Tatiana L. Gelardi

Office Action Summary

10/776,328

DETAILED ACTION

Fig 4 Kunimune '189.

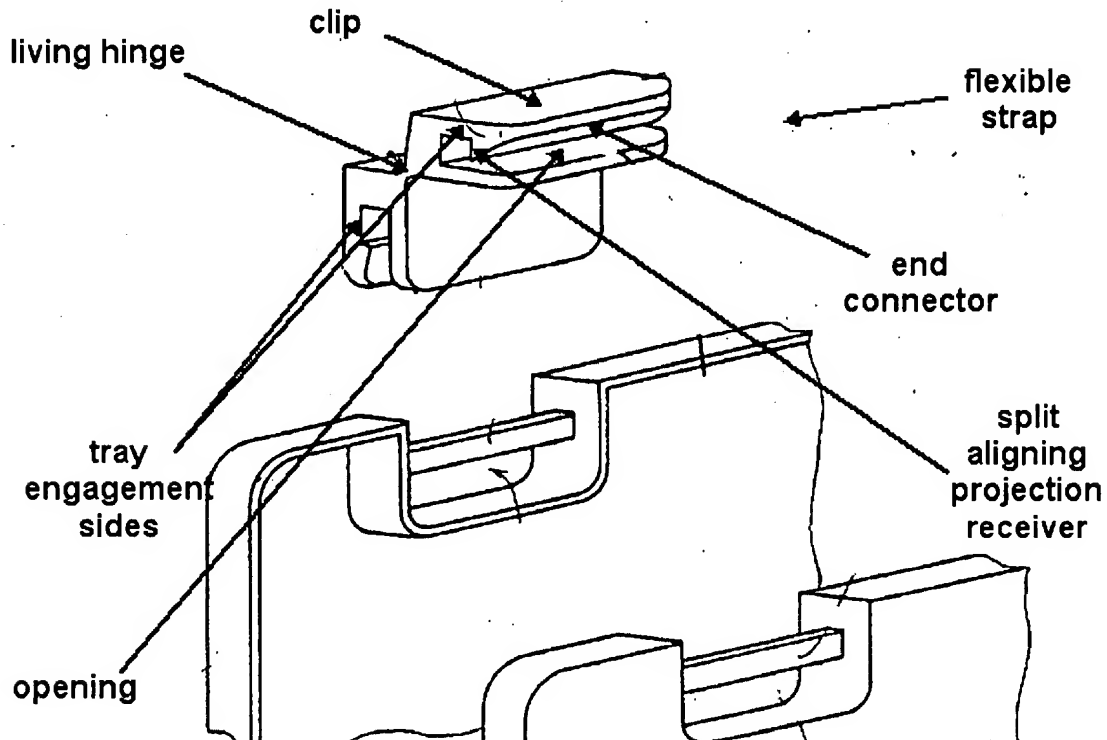
Claim 1 is rejected under 35 U.S.C. 102(b) as being anticipated by Kunimune et al (US Pat 4,892,189).

With respect to claim 1, Kunimune discloses a tray connecting apparatus (see Kunimune Fig 4 below) comprising: a flexible plastic strip having a central, longitudinal

each tray holder clip having opposite tray engagement sides projecting laterally from the central living hinge, the tray engagement sides having end connectors capable of fitting mounting recesses in tray edges, the end connectors having split aligning projection receivers at extremities capable of receiving aligning projections on the tray edge mounting recesses, and the tray holder clips having openings capable of receiving securing projections in the tray edge recesses.

Fig 4 Li '681.

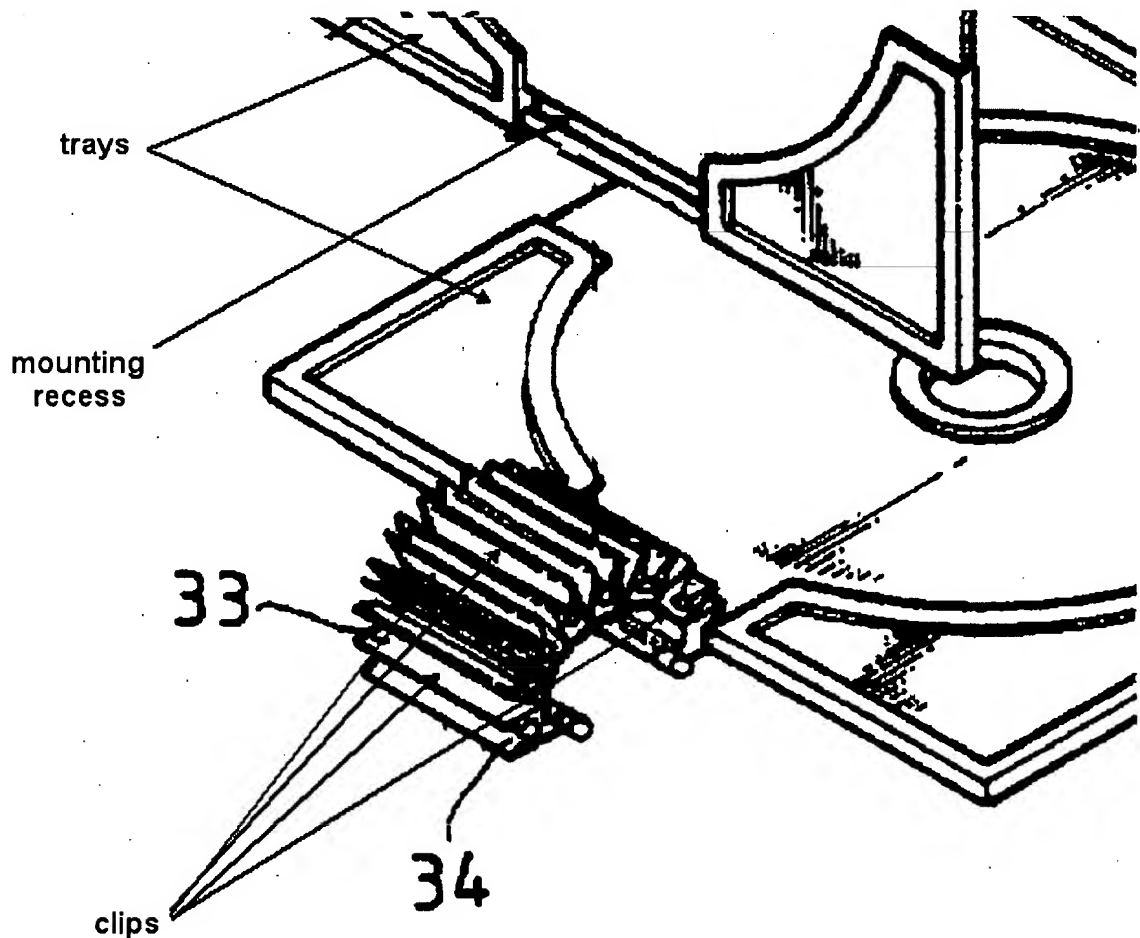
Claims 21-27 are rejected under 35 U.S.C. 102(b) as being anticipated by Li (US Pat 5,727,681).

With respect to claims 21 and 27, LI discloses a package comprising a stack of one or more individual trays (Li Fig 4), one or more sets of mounting recesses (44) along an edge of each individual tray, one or more sets of clips (Fig 5), wherein the number of sets of clips corresponds to the number of mounting recesses on the individual trays, wherein individual clips in each set are hinged (Fig 5 ref 36) by a living hinge relative to one another, and wherein the individual clips have connectors (at ref 35) for connecting the clips to the trays.

With respect to claims 22-24, Li discloses that the one or more sets of clips bend along a longitudinal axis for inserting into the one or more mounting recesses on the edges of the trays and that after the bent clips are inserted into the mounting recesses, pressure is applied to an exposed surface until the clips return to their initial configuration and for locking the clips into the mounting recesses. The reduced neck portions/detents (just below ref 35) bend along a longitudinal axis to maintain the trays raised block/ projections (ref 43) in the slot/hole (ref 34) of the clip until released (See Fig 4 and column 3, lines 21-26).

With respect to claim 21, Li Fig 4 clearly shows that the number of clips corresponds to the number of trays. With respect to claims 22 and 23, Li Fig 4 clearly shows the clips bending along the longitudinal (in a downward peelable fashion) axis and are capable of having pressure applied such that the clips can return to their initial configuration (compare Fig 5 and 6). With respect to claims 24-29, and in as much as Applicant has structurally defined "trapezoidal" and "dovetail" shapes and "locking ribs," Li clearly shows these limitations as described in the rejection above.

Fig 5 Li '681.

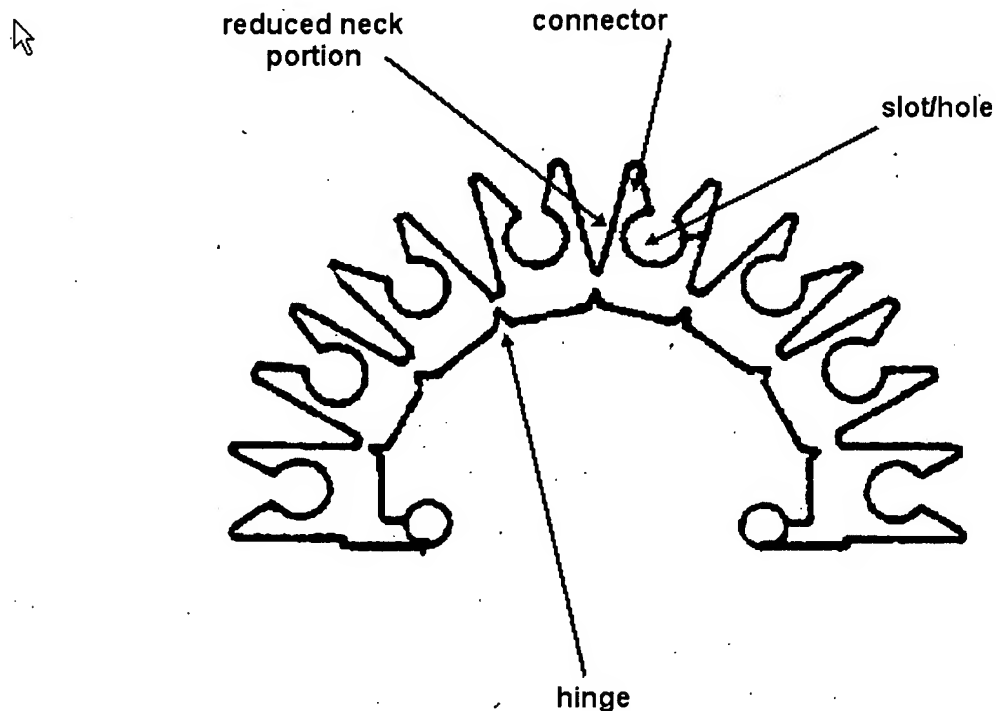
With respect to claim 26, Li discloses that the clips are trapezoidal (i.e. quadrilateral having at least two parallel sides; see Fig 5 generally) with triangles removed from a longer side surface (i.e. a triangle was removed from the upwardly extending projections at ref 35 such that the raised block of the tray could be more easily received by the reduced neck portion and into the slot) capable of bending the one or more clips along the longitudinal axis.

With respect to claim 29, Li discloses locking ribs (Fig 4 ref 43) projecting inward from ends of the mounting recesses on the individual trays and complementary grooves (Fig 5 ref 34) on ends of the one or more clips for receiving and holding the locking ribs. Li also discloses that the clip has a dovetail shape (see triangular portion of projection at 35). Li does not disclose that the mounting recesses have complementary dovetail shapes. However, it would have been an obvious matter of design choice to reshape the mounting recesses of Li to have complementary dovetail shapes so as to provide better complimentary fit between the recesses and clips, since such a modification would have involved a mere change in the shape of a component. A change in shape is generally recognized as being within the level of ordinary skill in the art. In re Dailey, 357 F.2d 669, 149 USPQ 47 (CCPA 1966). As to the remainder of claim 29,
